DEVELOPMENT APPLICATION ASSESSMENT REPORT

Application Number:	DA2024/0635
---------------------	-------------

Responsible Officer:	Maxwell Duncan
Land to be developed (Address):	Lot 2 DP 554948, 20 Beatty Street BALGOWLAH HEIGHTS NSW 2093
Proposed Development:	Demolition works and construction of a dwelling house including a swimming pool
Zoning:	Manly LEP2013 - Land zoned R2 Low Density Residential
Development Permissible:	Yes
Existing Use Rights:	No
Consent Authority:	Northern Beaches Council
Delegation Level:	DDP
Land and Environment Court Action:	No
Applicant:	Samuel Paul Allen

Figure 1: Section plan - Height of building variation in pink.

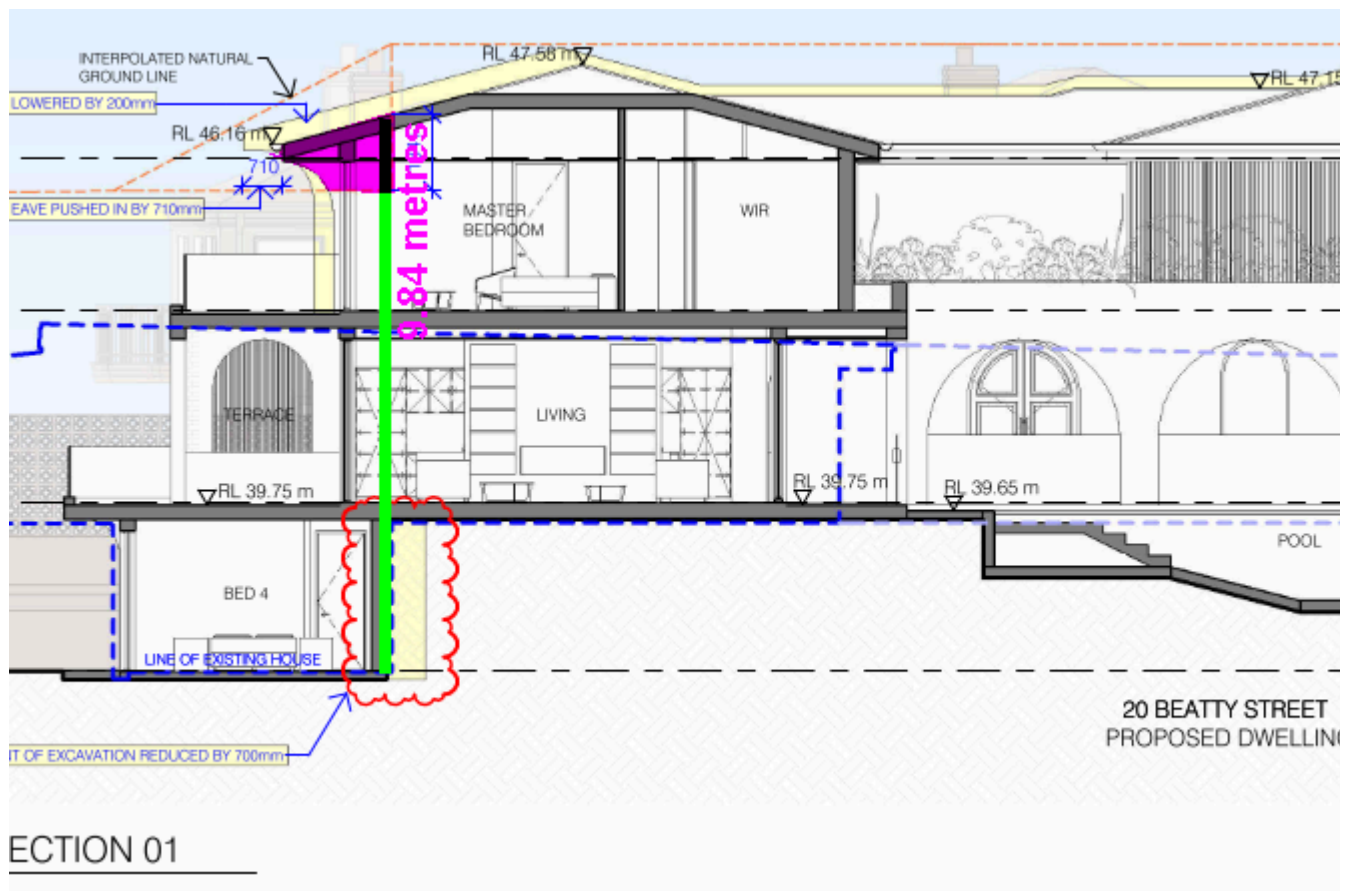
Proposed: 9.841m

Percentage of variation: 15.77%

- The building height of the proposed development is consistent with that of surrounding development and development within the visual catchment of the site. The non-compliance occurs as a result of historical excavation in a minor area of the site, which is not representative of the topographic landscape of the locality. In this respect, it is noted that the proposed development is otherwise compliant with the height plane, excluding the anomaly of the ground plane created by the existing excavation.*

*The proposed height breach is a direct consequence of existing excavation. As demonstrated on the Height Plane Diagram at Figure 3 on the following page, the proposed development is compliant with 8.5m height plane when measured to existing ground levels along the perimeter of the building and when the area of existing excavation is excluded. Consistent with the findings of Commissioner O'Neill in *Merman Investments Pty Ltd v Woollahra Municipal Council* [2021] NSWLEC 1582, prior excavation within the building footprint that distorts the height of buildings development standard plane can be properly described as an environmental planning ground within the meaning of clause 4.6(3)(b) of the LEP.*
